Interception Drainage Note

Project	Sefter Farm Engineering Block
Project Number	24125

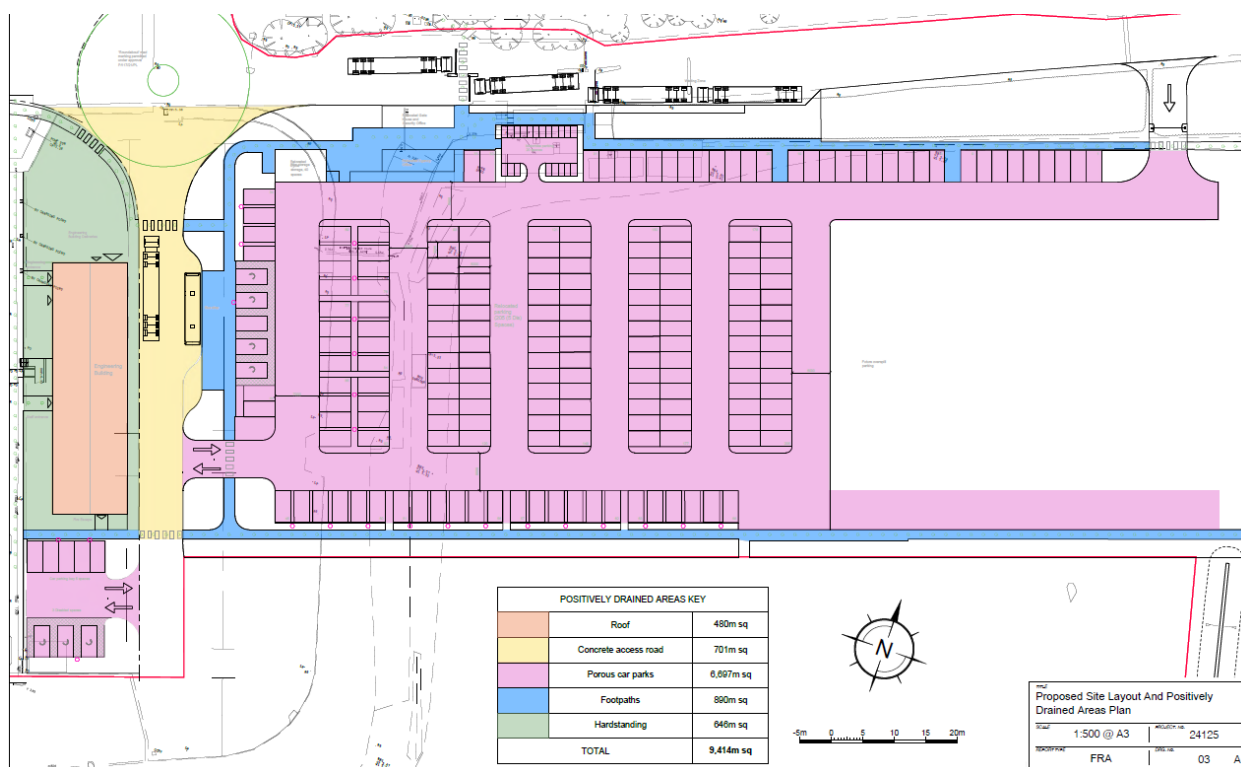
- 1.4 The extract below details the drained area as submitted. The Pink (car park and access) and Blue (footway) areas are permeable pavements. The Yellow (access road), Green (hardstanding) and Orange (roof) area also drain through the permeable paving.

- 1.5 Arun Engineers have confirmed the permeable paved areas (Pink and Blue) above are acceptable to meet interception for those self drained areas.

- 1.6 The Access Road, Hardstanding and Roof areas all drain through the permeable paving. 5mm of rainfall from these areas generates $(701 + 646 + 480) \times 0.005 = 9.135\text{m}^3$ of surface water.
